# Final Environmental Impact Report

*Project*  
**Valley Christian Center  
Expansion Program**

*Lead Agency*  
**City of Dublin**

**March 2003**

**FIGURE 2**  
**SITE GEOLOGIC MAP**  
 VALLEY CHRISTIAN CENTER  
 ROBERT Y. CHEW GEOTECHNICAL, INC.  
 SAN FRANCISCO, CALIFORNIA  
 HAYWARD, CALIFORNIA

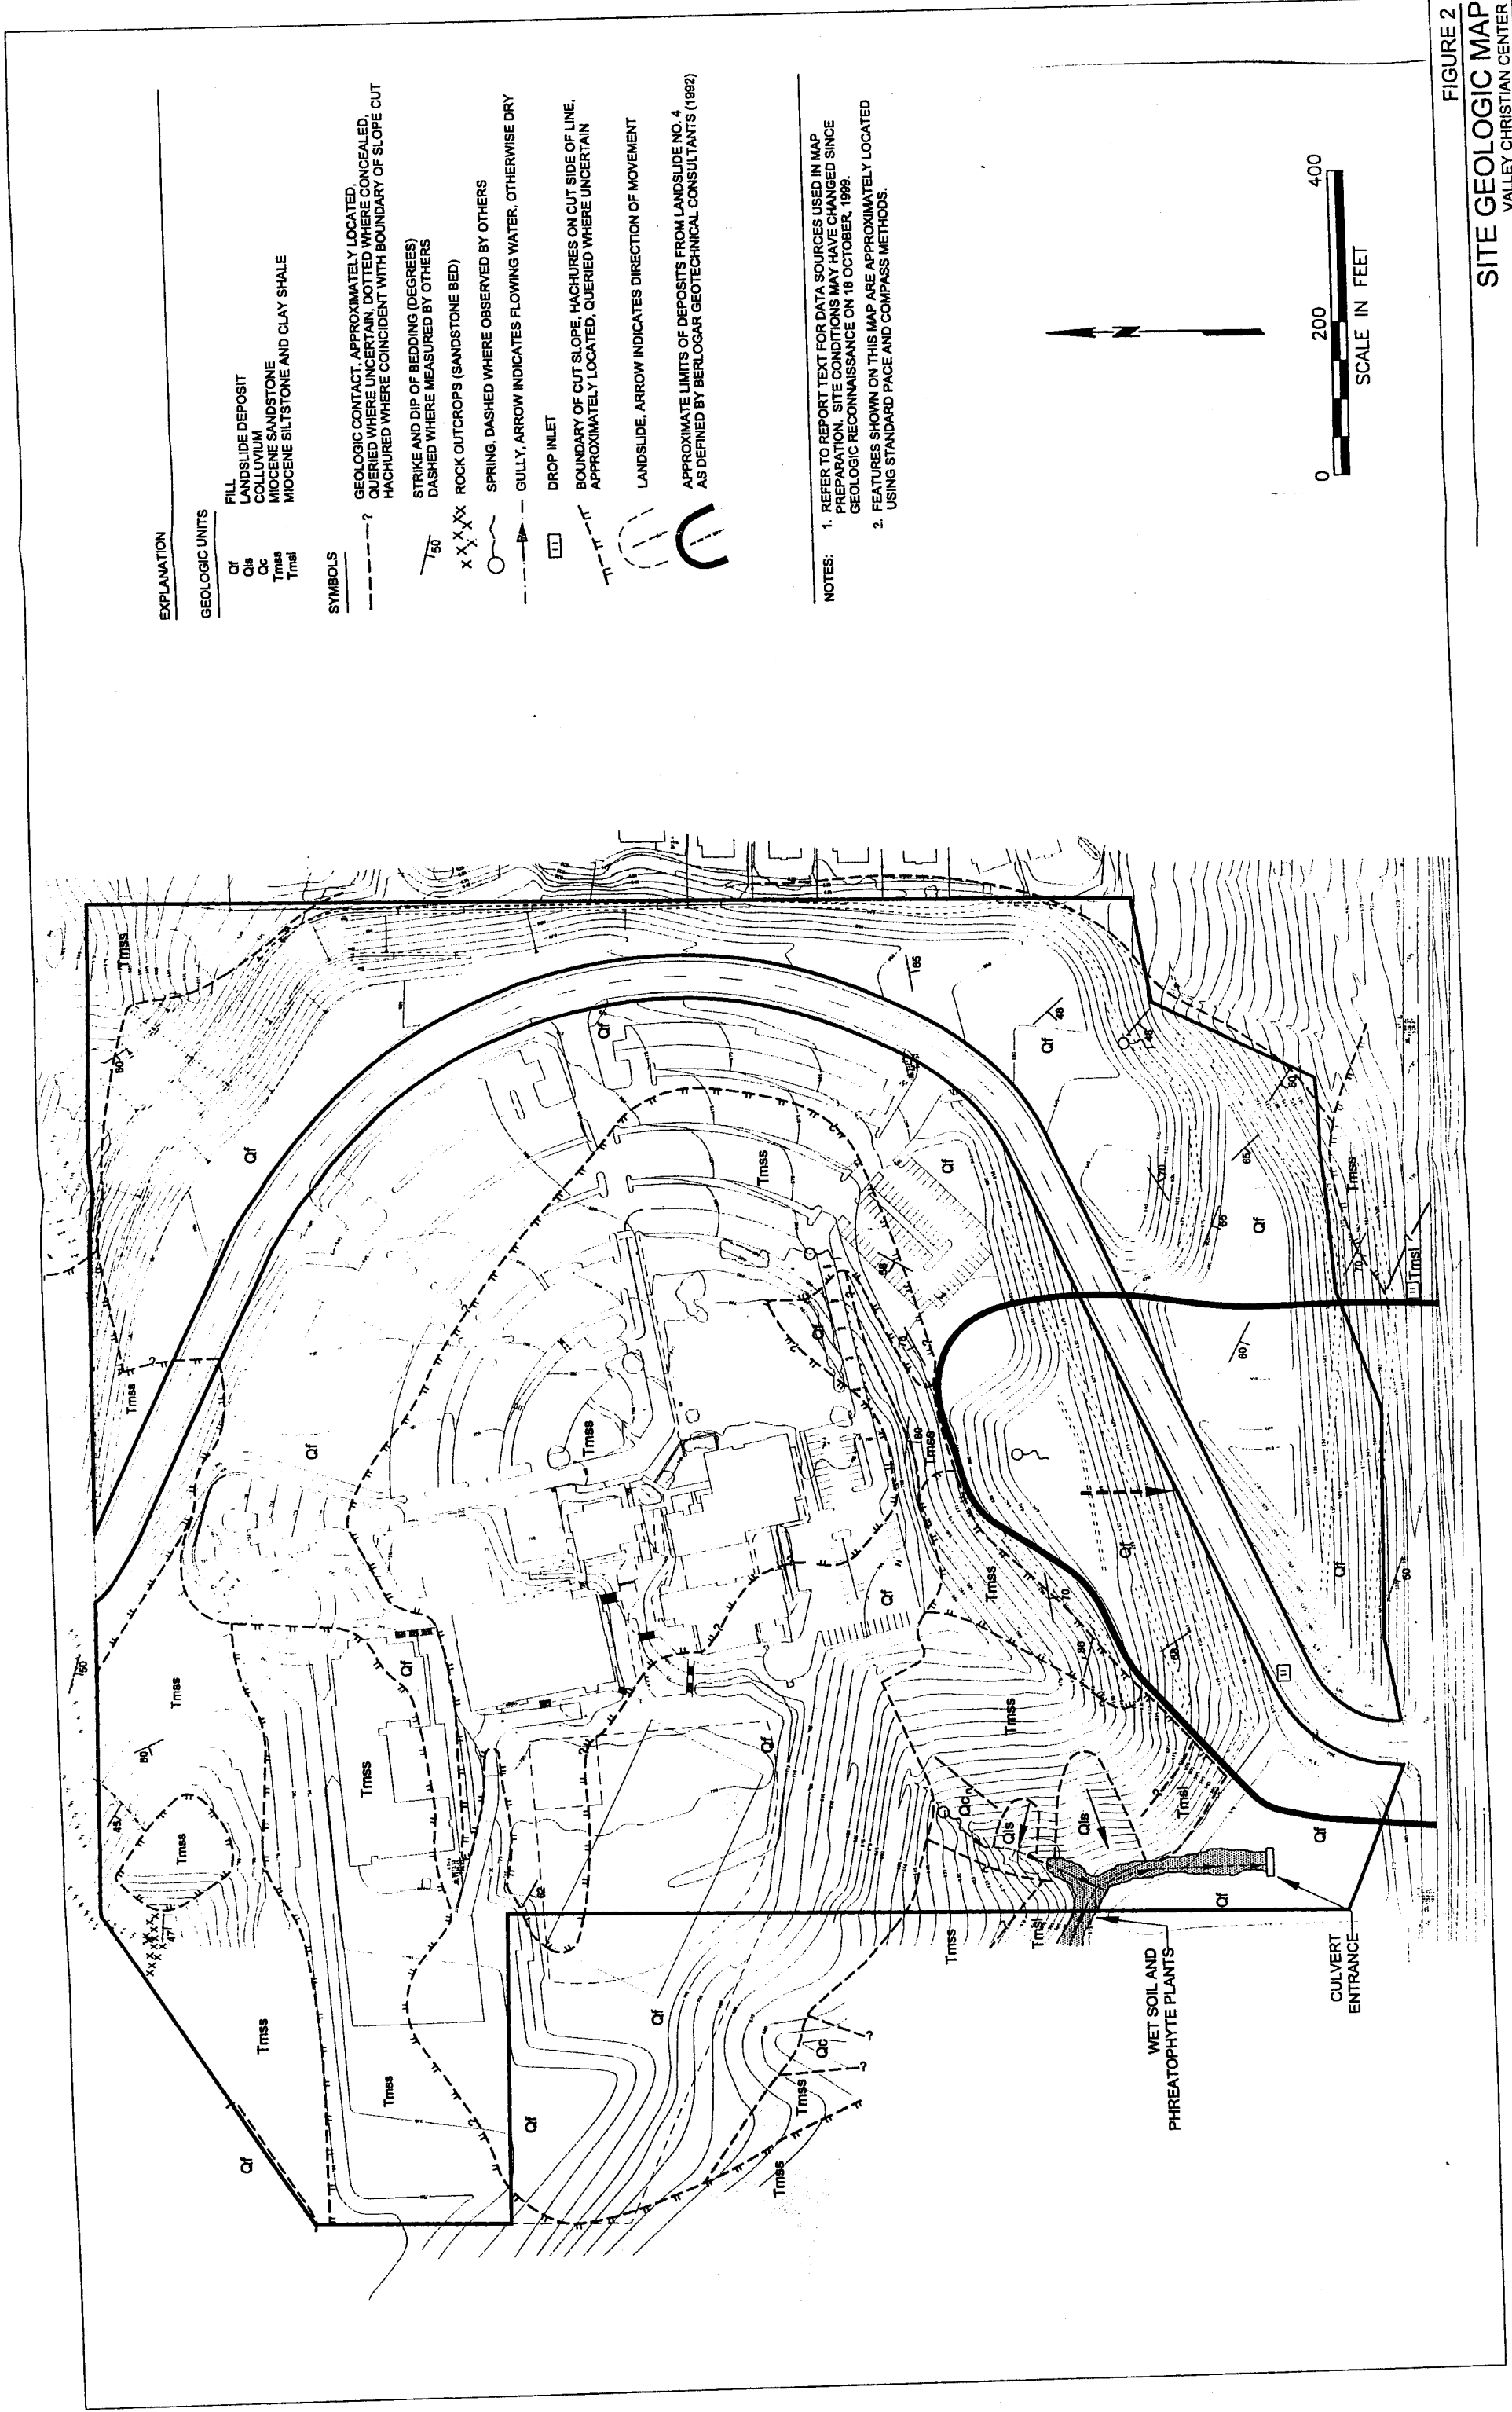
- Comment 4.7.2: The commenter would like to know the area of possible expansive soils and landslides on the site in regard to adjacent residents. Also, the location of the Dublin fault should be identified.

*Response:* The Geology section of the DEIR (Section 4.5) describes a large landslide on the project site that was identified and mapped in 1975, which generally trends in a north-south direction from higher elevations to lower elevations. An exhibit from the Robert Chew soils report that shows the approximate location of landslides is attached to this document. Two other smaller landslides have been identified in the southwestern portion of the site. The exhibit also shows portions of the site with surface deposits of
